PG&E Letter DCL-00-116

Docket No. 50-275, OL-DPR-80
Docket No. 50-323, OL-DPR-82
Diablo Canyon Units 1 and 2
Emergency Plan Implementing Procedure Update

PREPARER	1. PROCEDURE NO. EP RB-15	2. CURRENT REV. 8	3. UNIT <input type="checkbox"/> 1 <input type="checkbox"/> 2 <input checked="" type="checkbox"/> 1&2

TITLE: Post Accident Sampling System

FIGURE 1b

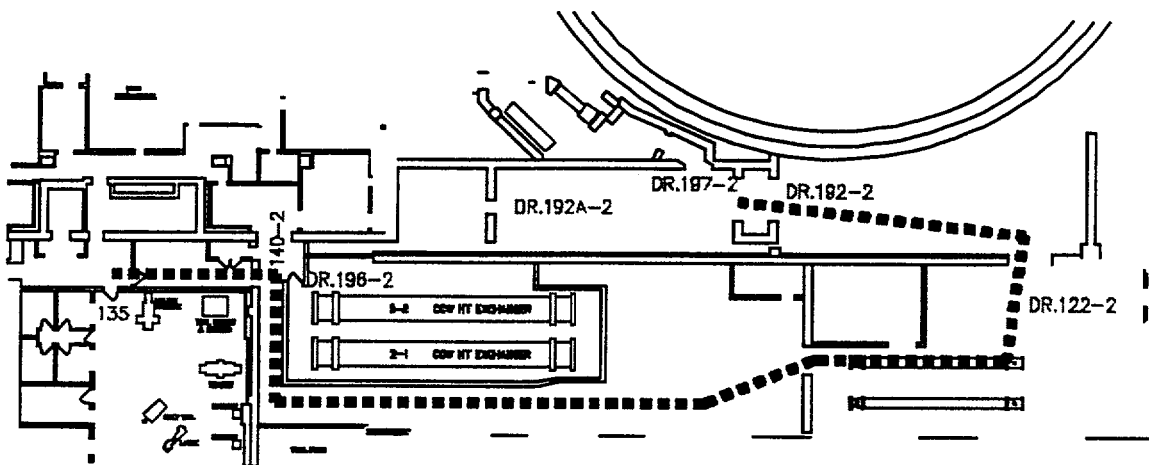
Starting at the Cold Machine Shop proceed into the hallway to door #140, proceed south to door #122 and exit building. From here turn north and enter door #122 to the Motor Repair Shop.

192-2

FIGURE 2b

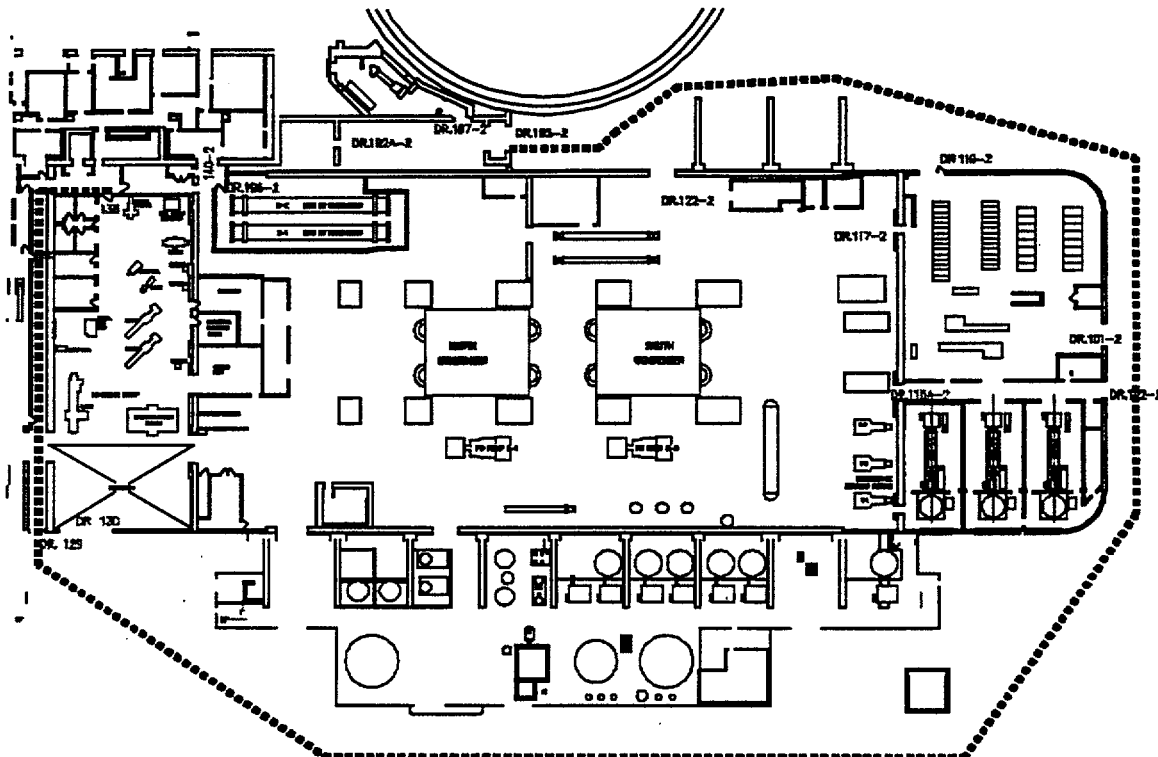
Starting at the Cold Machine Shop proceed to the outside via door #129, turn left and continue south around the Unit 2 Turbine Building looping around the transformers at the south end of the plant. Continue north to door #192 between containment and the Turbine Building. Enter the Motor Repair Shop via door #~~192~~ 192-2.
